Diavik Mines PKMW Hydrodynamic and Water Quality Modelling: Independent Review Panel Final Report

October 15, 2020

Table 1. Independent Review Panel (IRP) comments and information requests presented to Diavik Mines after September 24 workshop.

Figure A: Comparison of the volume compressibility relationships

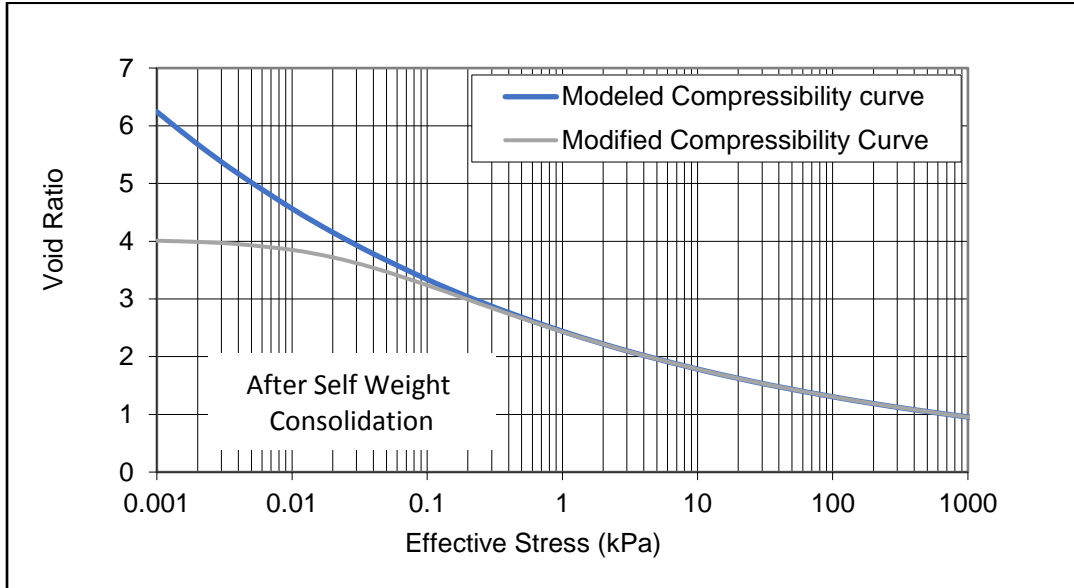
The above-mentioned volume compressibility relationship does not clearly differentiate between the two distinct dewatering processes of sedimentation and consolidation. To understand the initial release of pore water, an extended power law function is usually selected to better capture the settling behavior of slurries under low values of effective stresses (Liu and Znidarcic, 1991). Using fit parameters (A, B, and Z), the test data is fitted to the following modified volume compressibility relationship:

Figure A gives a comparison of the two volume compressibility equations. Using $Z = 0.025$ to achieve $e = 3.5$ at $\sigma' = 0.1$ kPa (initial void ratio used for LSC modeling), the modified equation indicates that the grit-

rich FPK containing 33% fines has to be deposited at $e = 4.0$ as opposed to the modeled equation that requires a much leaner slurry. The sensitivity case (Table 1) in LSC modeling was not described (Golder 2020a).

- Model sensitivity for initial conditions (void ratio of 6.85 to 3.5), should be further explored using the two different constitutive relationships for volume compressibility. This will provide a design criteria for selecting an appropriate solids content at the onset of deposition that, in turn, will help in estimating the rate/quantity of the released pore water in the pit.

Figure B: Comparison of assumed 1-D column with the 2-D geometry of A418

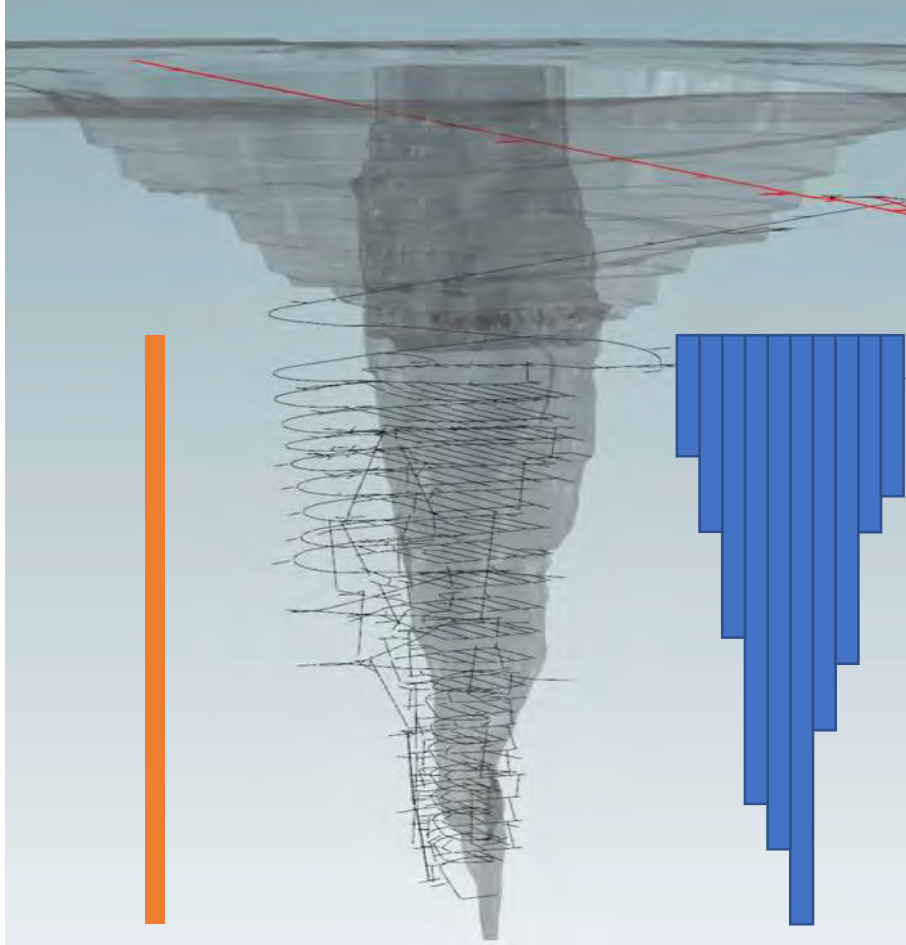
The LSC modeling simulated 1-D column situated at the centre of A418. This column represented the maximum depth of the deposited FPK in the pit. Figure B gives a comparison of the 1-D column (red) using the 2-D pit geometry, as illustrated in Figure 8 (Golder 2020a): the third dimension is perpendicular to the plane of the paper.

As shown above, the LSC modeling assumed that the surrounding slurries (with reduced height) settle at the same rate as the tallest one (that is, foundations also settle). This provides an approximate solution of the 3-D settling of the deposited FPK in A418. The discrepancy in model prediction and actual field performance depends on material properties (discussed earlier) and the pit geometry.

The grit-rich FPK is planned to be deposited between 8795 m and 9205 m with the corresponding diameters of about 80 m and 170 m, respectively. For an inverted cone of varying dimensions, actual survey assessment (such as bathymetric data) and/or a more robust 3-D numerical analysis (such as that described in Pinho and Filho (2020)) are required.

- It is recommended to conduct ongoing bathymetric assessment during deposition and/or a more robust 3-D numerical modeling at the onset of deposition. This will confirm the final configuration of the deposited FPK in the pit that, in turn, will be used for model iteration 4 before flooding A418 with water.

Figure 3.1 (adapted from Slide 23 of Webinar 2 model presentation). Water elevation in Pits A418 and A154.

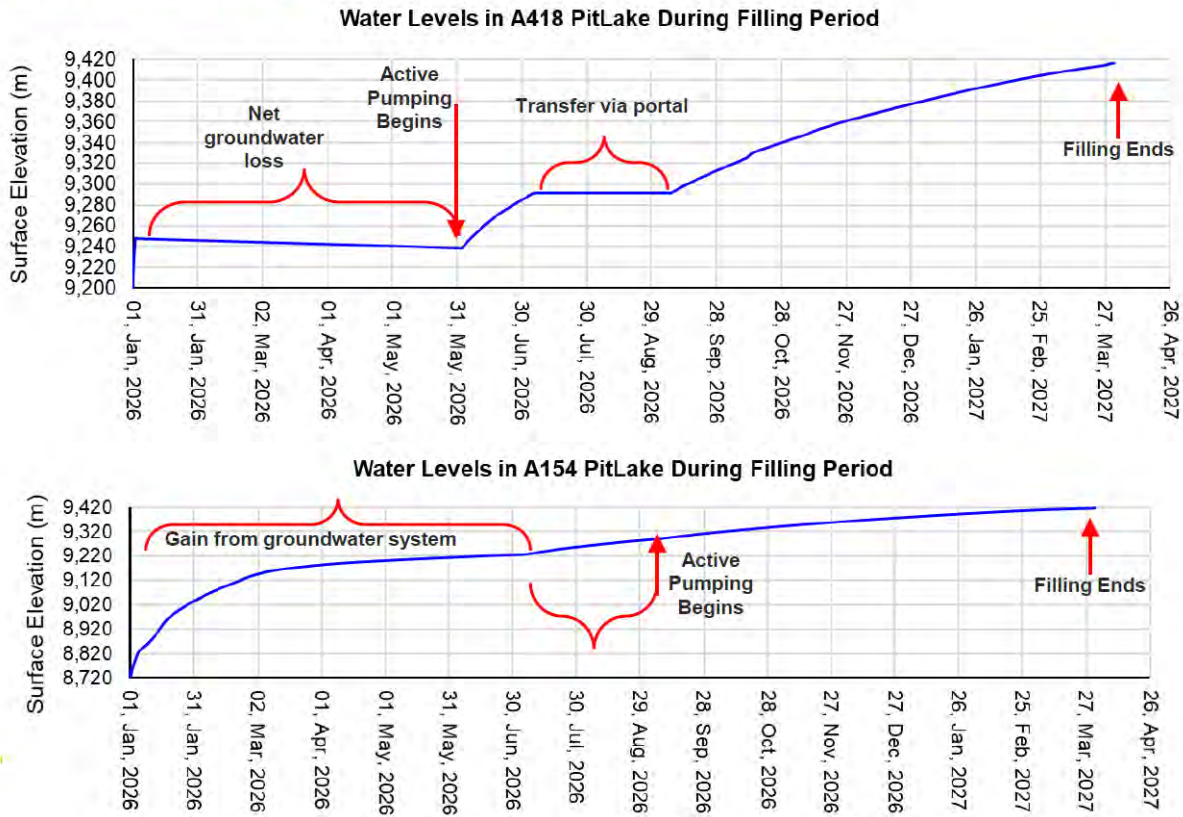
Beginning in June 2026, the A418 pit is filled until the water level reaches the portal connecting A418 to A154. At this level water freely flows from A418 to A154 until the water levels in each pit equilibrate. Note that prior to this, the only pathway for water to move to A154 was through via ground water. A148 and A154 are both actively filled after equilibrating until May 2027 when both pits are full.

In the base case model only 1.2% of the approximately 30 million m³ of total water in A418 is made up of decant (slurry) water and a comparatively small amount of porewater released during the 16-month fill period (Table 3.1). If there were no water lost from A418 to A154, the porewater would comprise nearly 6% of the volume at the end of filling. The base case loss of porewater to A154 is approximately 80%.

Table 4.1. List of Concerns for modeling the A418 pit using CE-QUAL-W2 and the Mike3 breach model.

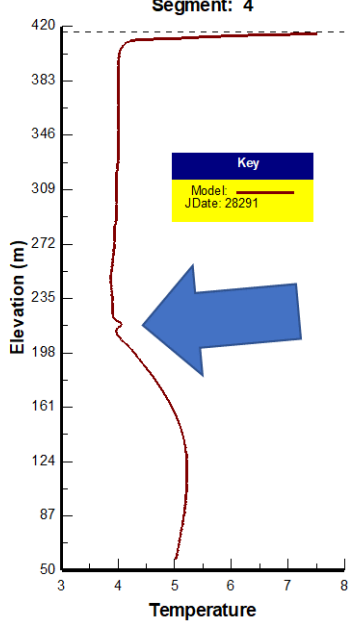
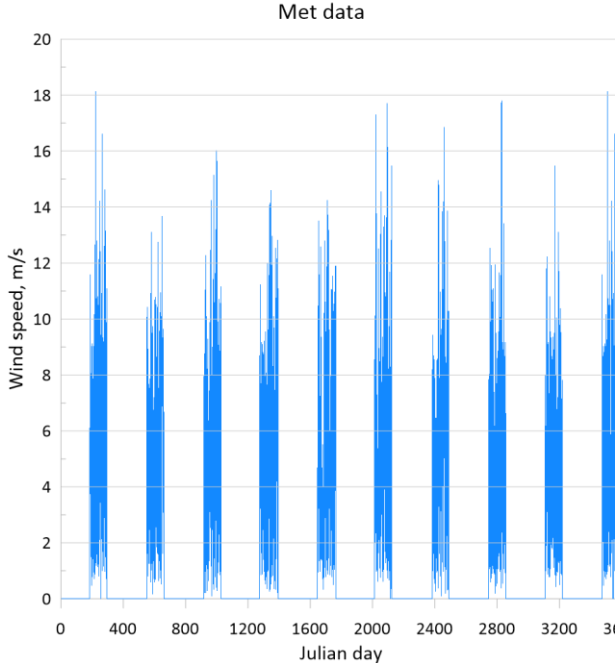
Point #	Concern	A418 Water Quality Implication	Action Item
IRP 3.1	<p>Portal between A418 and A154 not modeled in CE-QUAL-W2</p> <p>Background: From Golder (2020), the portal (apparently rectangular with dimensions of 5 m X 5m) between A418 to A154. The portal is located at 9290 m in A418 (and 9270 m in A 154). As stated in the documentation, “water transfers from A418 to A154 through portal”.</p>	<p>Because this portal is connecting 2 pits and is in contact with the ground, there is the possibility that convective currents could be induced that may enhance mixing in A418 (and/or in A154).</p>	<p>Perform an evaluation of movement of water stored in the portal into A154 or A418 and evaluate whether this could affect A418 water quality.</p>
IRP 3.2	<p>Groundwater not included in CE-QUAL-W2 model even though documentation showed groundwater was included.</p>	<p>Groundwater is not included in the CE-QUAL-W2 model after the pit is filled. It is not unreasonable to neglect groundwater since this would be a conservative assumption (the groundwater concentrations would generally be of better quality than the mine tailings).</p>	<p>Revise figure in CE-QUAL-W2 documentation.</p>

IRP 3.3	<p>A spillway required to balance flow in the A418 CE-QUAL-W2 model. This point is one of several points mentioned below that focus on the linkage of the CE-QUAL-W2 model and the Mike3 Breach model.</p> <p>Background: The inflows into A418 through the 2 breaches was computed using a Mike3 model. The inflow and outflow predicted from the Mike3 breach model did not agree with the water balance in the CE-QUAL-W2 model. The CE-QUAL-W2 model had more water coming into it (or less water loss) than the Mike3 Breach model. As a result, to keep the water level at 416 m and not</p>	<p>Mike3 Breach model and W2 model are not completely compatible regarding the water balance between the 2 models. This can affect the amount of mixing of clean water from Lac de Gras affecting surface concentrations in A418.</p>	<p>Review water balance in A418 CE-QUAL-W2 and Mike3 model and evaluate ways to better synchronize the 2 models and whether the current situation is conservative or not.</p>

Point #	Concern	A418 Water Quality Implication	Action Item								
	<p>higher, a spillway was added that lost water. This water was not transferred anywhere, it was just lost from the system.</p> <p>The spillway water loss is a significant part of the water balance, as shown in the pie chart below:</p> <p style="text-align: center;">A418 Water Balance</p>
